# Access Compliance Report

## Public Rights-of-Way

### (Curb Ramps)

Intersection ID: 10019560	Main Street: ALMA_BLOUNT_BV	Cross Street: N/A	Location: SE
ADA ID: 06473F9A671B	Ramp Type: PerpDiag	Initial Pass/Fail: Fail	Overall Compliance: No
		Severity Score: 12.5

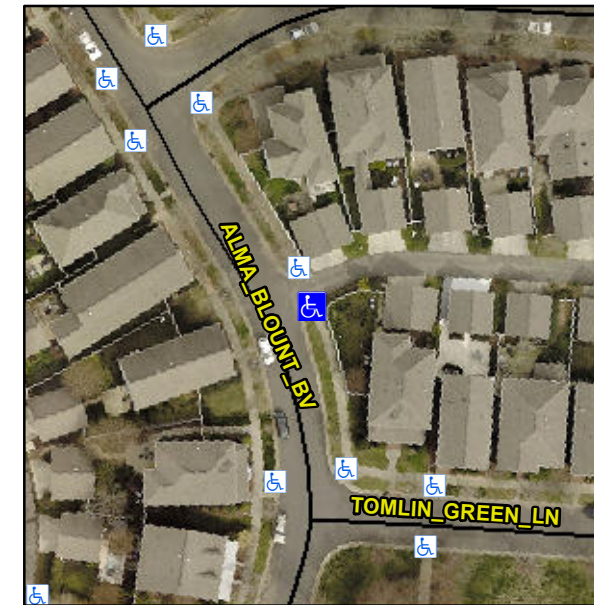
**Not Found, R304.2.2**

Compliance	Description	Data	Compliance	Description	Data
N/A	Ramp Length (in)	70.0	No	Ramp Slope (%)	8.8
Yes	Ramp Width (in)	48.0	Yes	Ramp XSlope (%)	0.6
N/A	Flare Type LT	N/A	N/A	Flare Type RT	N/A
N/A	Flare Slope LT (%)	N/A	N/A	Flare Slope RT (%)	N/A
N/A	Flare Traversable LT?	N/A	N/A	Flare Traversable RT?	N/A
N/A	Landing Length (in)	N/A	N/A	DWS Provided?	N/A
N/A	Landing Width (in)	N/A	N/A	DWS Contrast?	N/A
N/A	Landing Slope (%)	N/A	N/A	DWS Length (in)	N/A
N/A	Landing X Slope (%)	N/A	N/A	DWS Full Width?	N/A
N/A	Landing Curb? (Y/N)	N/A	N/A	DWS Offset (in)	N/A
N/A	Shared Landing?	N/A			
N/A	Gutter Ponding?	Yes	N/A	Gutter Slope (%)	N/A
N/A	Gutter Lip Ht (in)	N/A	N/A	Gutter X Slope (%)	N/A
N/A	Painted X Walk1?	No	N/A	Painted X Walk2?	No
	X Walk 1 Direction	To N		X Walk 2 Direction	To W
N/A	X Walk 1 Width (in)	N/A	N/A	X Walk 2 Width (in)	N/A
	X Walk 1 Slope (%)	0.3		X Walk 2 Slope (%)	2.3
	X Walk 1 X Slope (%)	1.2		X Walk 2 X Slope (%)	0.2

**Remove & Replace Curb Ramp With Two New Directional Ramps or Equivalent.**
